GARDEN MEADOW ADDITION

S/D 98-38 - Final Plat of GARDEN MEADOW ADDITION

At the regular meeting of the Subdivision Committee of the Metropolitan Area Planning Commission on Thursday, August 20, 1998, the above captioned plat was considered. The action of the Committee was to approve the final plat, subject to the following:

CASE NUMBER: S/D 98-38 - GARDEN MEADOW ADDITION
(formerly HENDRICK'S GARDENS)

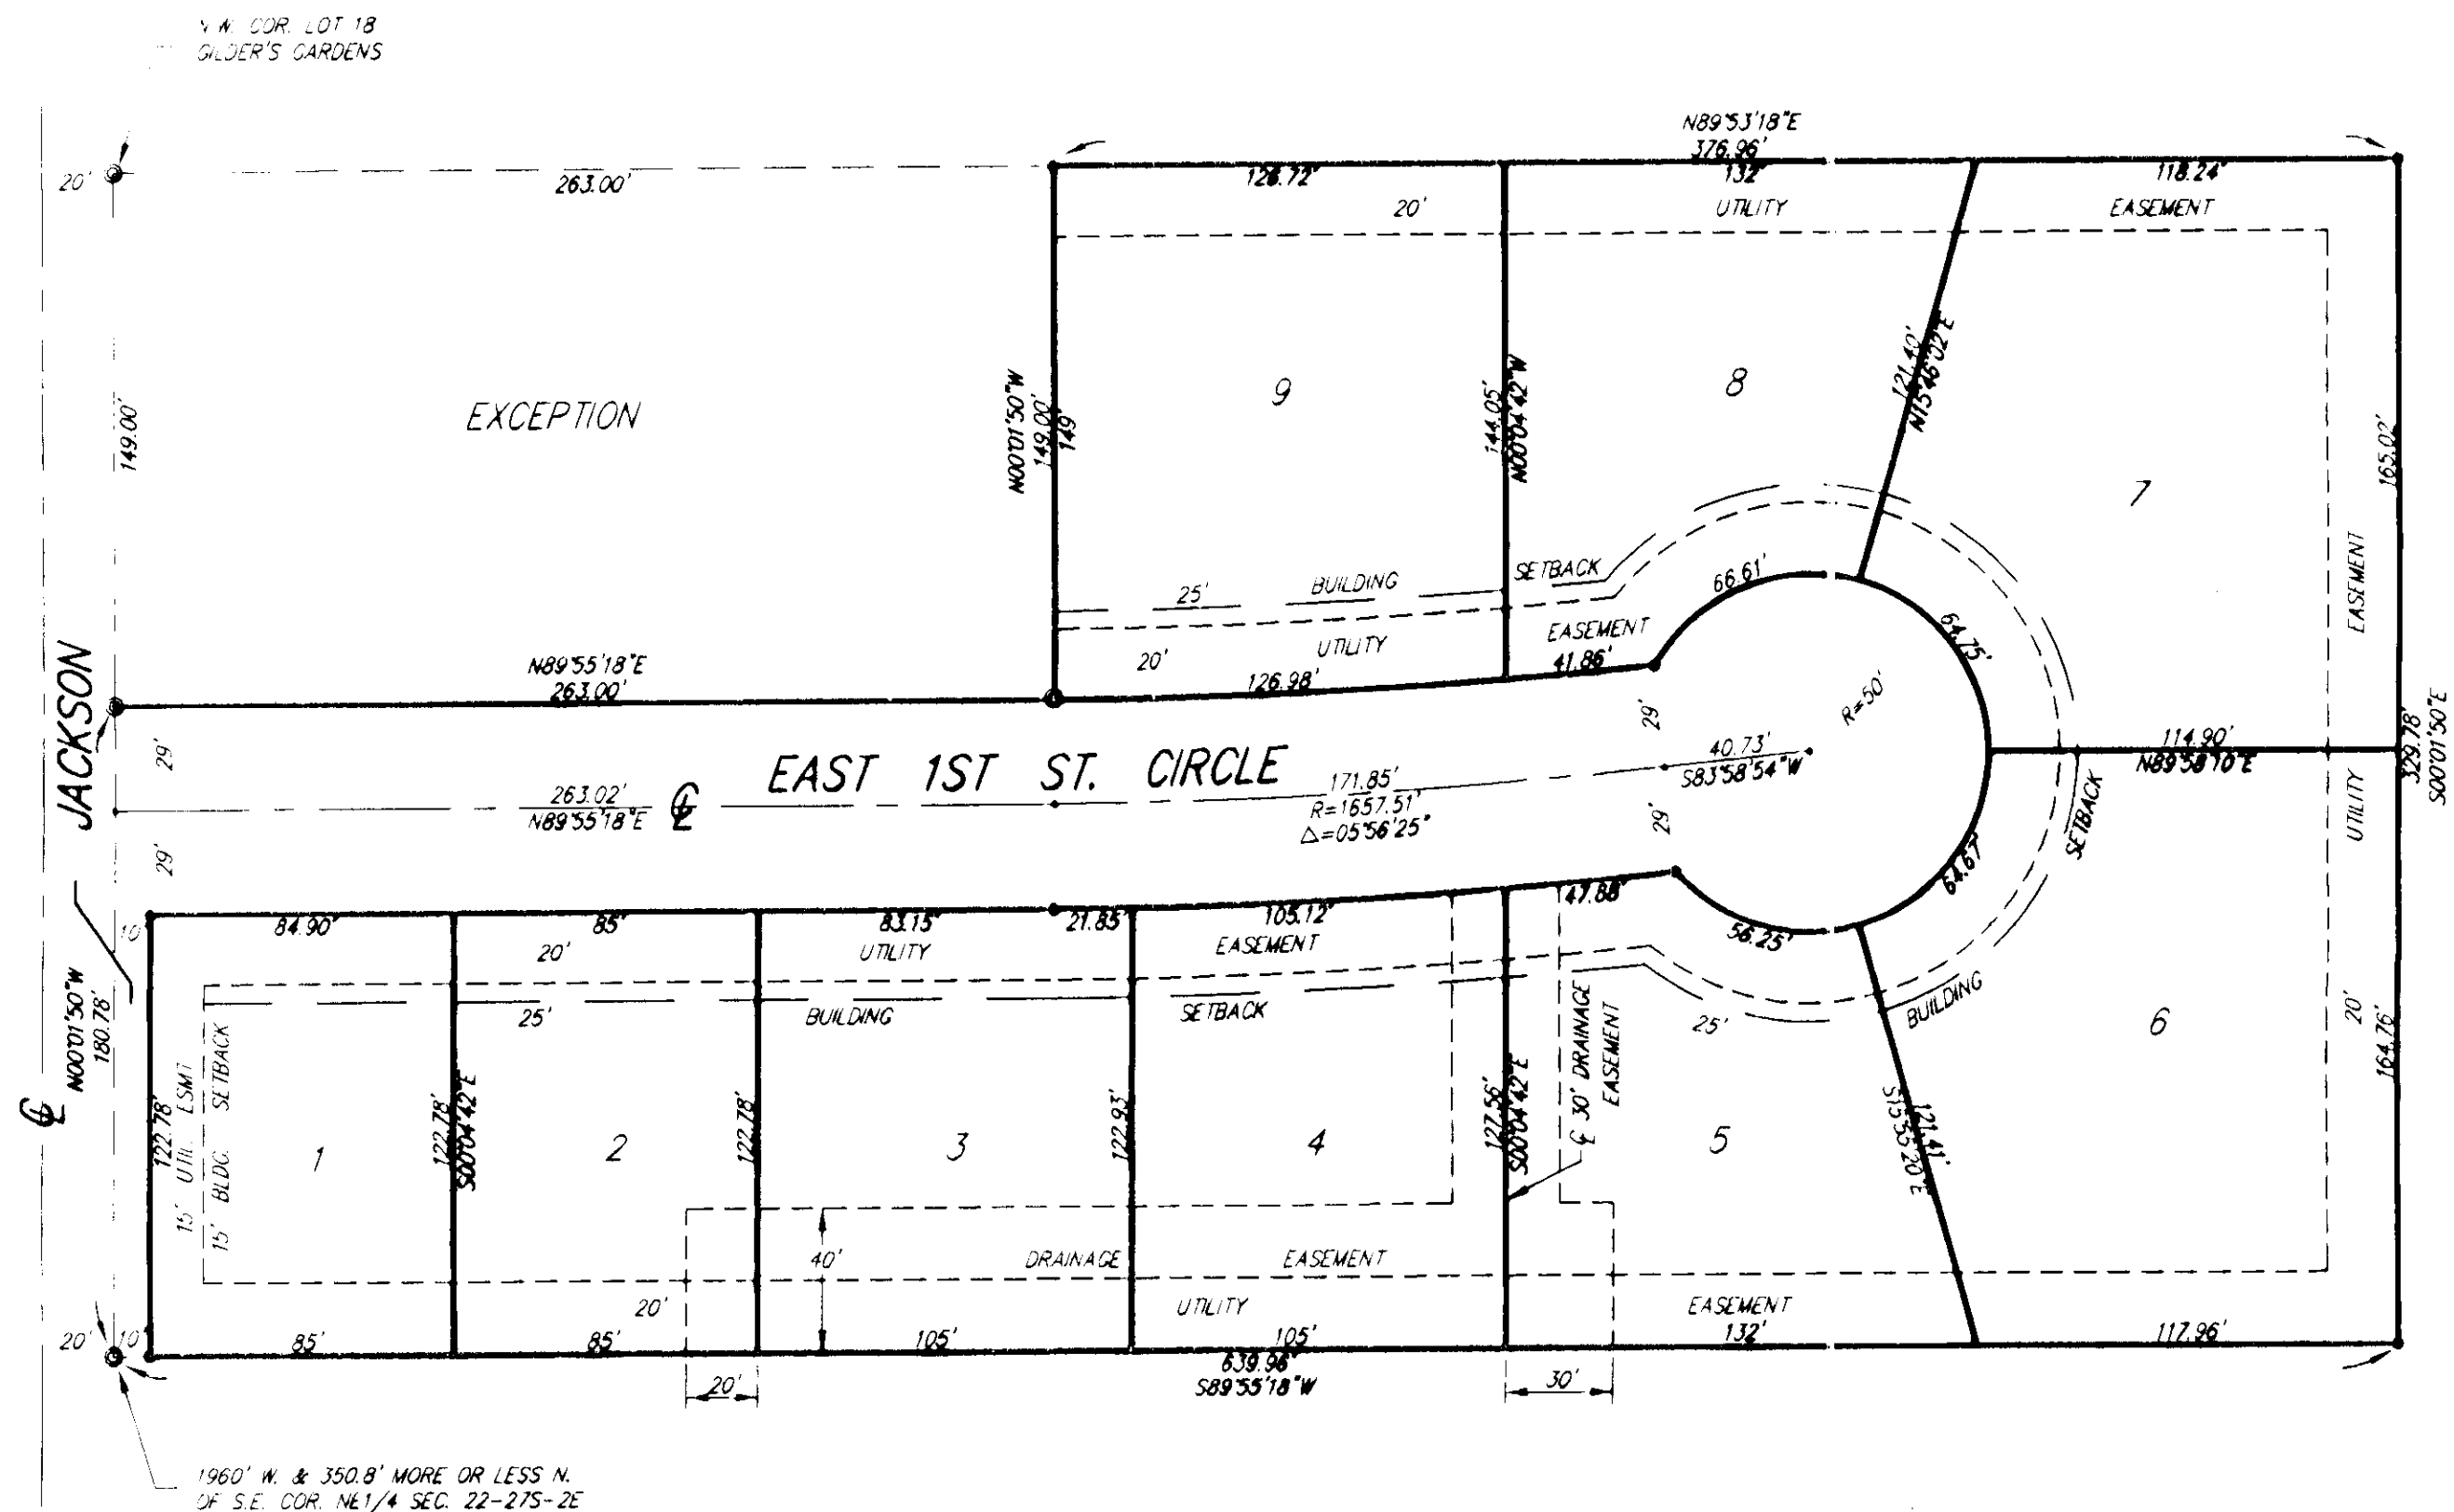
- A. City water appears to be available to this site. The applicant shall guarantee the extension of sanitary sewer to serve the lots being platted. This guarantee shall be with the County for service through the Four Mile Creek sanitary sewer system. On the final plat tracing, appropriate wording shall be added to the Mayor's signature block indicating the City's agreement to allow a County sewer district to be formed within the City. **A guarantee for City water will also be needed. A sanitary sewer layout is requested by County Engineering.**

- C. **City Engineering** needs to comment on the status of the applicant's drainage plan. **The drainage plan has been approved. An off-site drainage easement will be needed.**

- D. The applicant shall guarantee the paving of the proposed interior street.
- E. The applicant shall submit a covenant which provides for four (4) off-street parking spaces per dwelling unit on each lot which abuts a 58-foot street. The covenant shall inventory the affected lots by lot and block number and shall

- F. Traffic Engineering needs to comment on the need for improvements to Jackson Street. An agreement not to protest future street improvements is requested from the applicant.

- G. For any lots with existing tree rows that may be impacted by the installation of utilities, it is recommended that overly wide utility easements (30 foot) be platted in order to allow for the installation of the utilities without damage to such tree rows. Sanitary sewer and KG&E services are proposed to be constructed along front yard easements and applicant prefers to maintain 20-foot rear yard easement.

- H. Fire Department requests that the street be renamed "E. 1st St. Circle".
- I. On the final plat tracing, the spelling of "granted" in the owner's signature block needs to be corrected, in addition to "Hendrick".

- R. The representatives from the utility companies should be prepared to comment on the need for any additional utility easements to be platted on this property. **KG&E and Southwestern Bell request additional easements which have been denoted on the final plat.**
